#### D3327-041 BASKET LID ASSEMBLY

DRAWING NO. D3327	TITLE BASKET LID ASSEMBLY	REV. B	<b>DART AEROSPACE LTD ENGINEERING ORDER</b>		D.E.O. NO. D3327-B-1	SHEET NO. SHEET 1 OF 1	SCALE NTS
DRAWN AJS	CHECKED <i>[Signature]</i>	MFG. APPR. <i>[Signature]</i>	APPROVED <i>[Signature]</i>		DE APPR. <i>[Signature]</i>		
DATE 08.11.28	DATE 08.11.28	DATE 08.12.01	DATE 08.12.01		DATE 08.12.01

#### PARTS LIST FOR D3327-041 BASKET LID ASSEMBLY

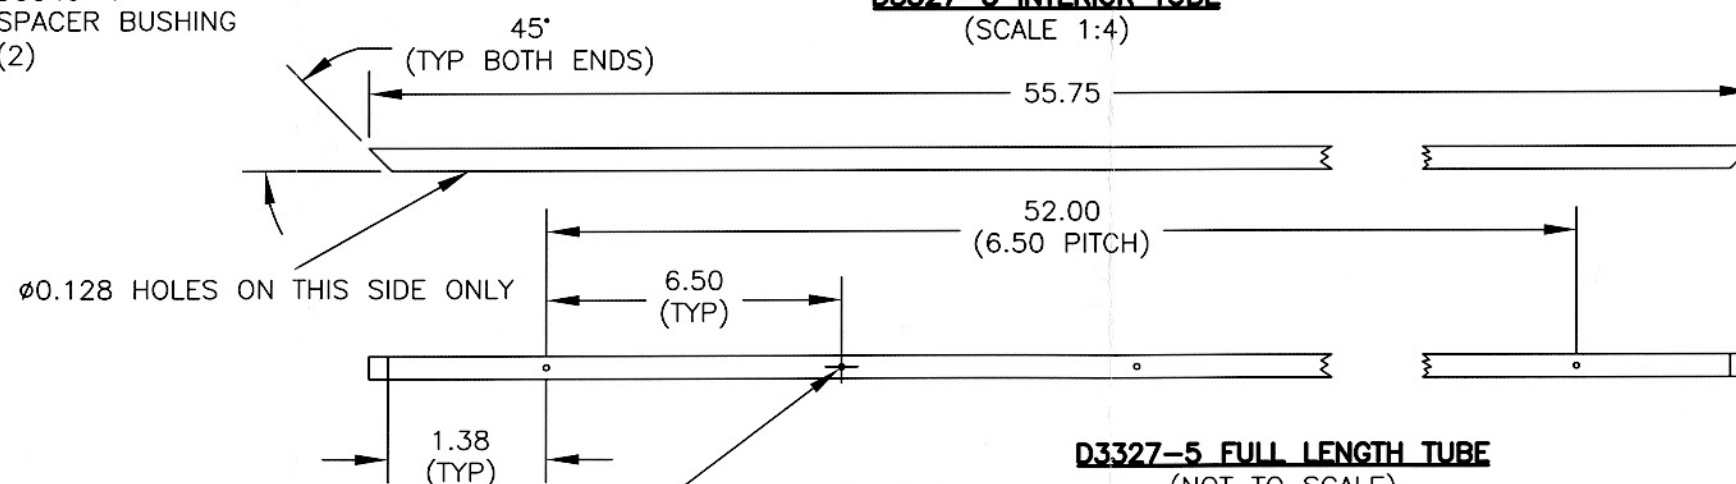
1) SHEET 1 MODIFY PARTS LIST AS SHOWN:

**WAS:**

MS20600AD4W3	24	RIVET

**IS:**

MS20600AD4W5	24	RIVET

DETAIL B  
TYP. ATTACHMENT OF WEBBING TO LID  
FRAME  
(SCALE 1:1)

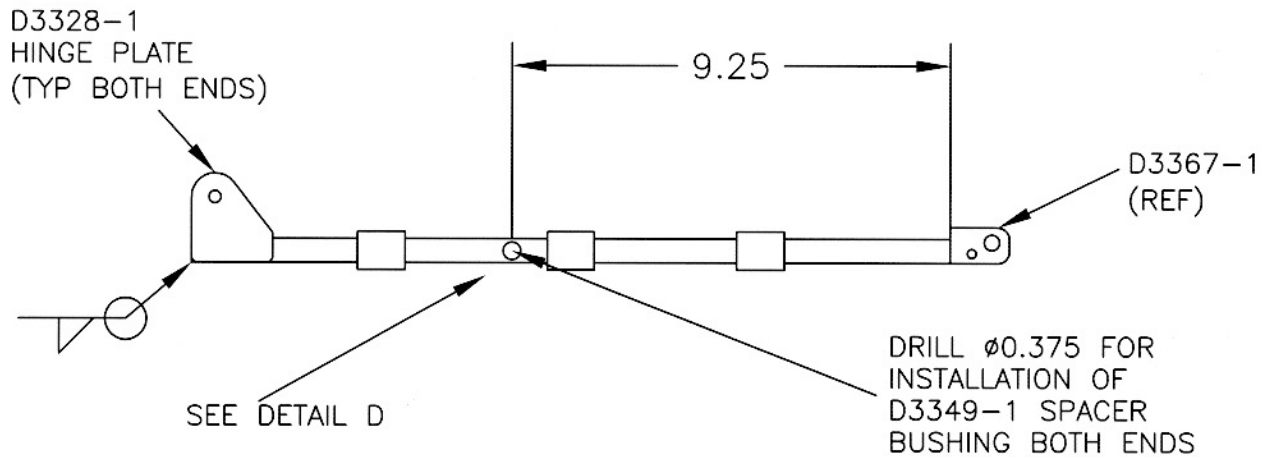
2) UPDATE SHEET 3 DETAIL B ACCORDINGLY.
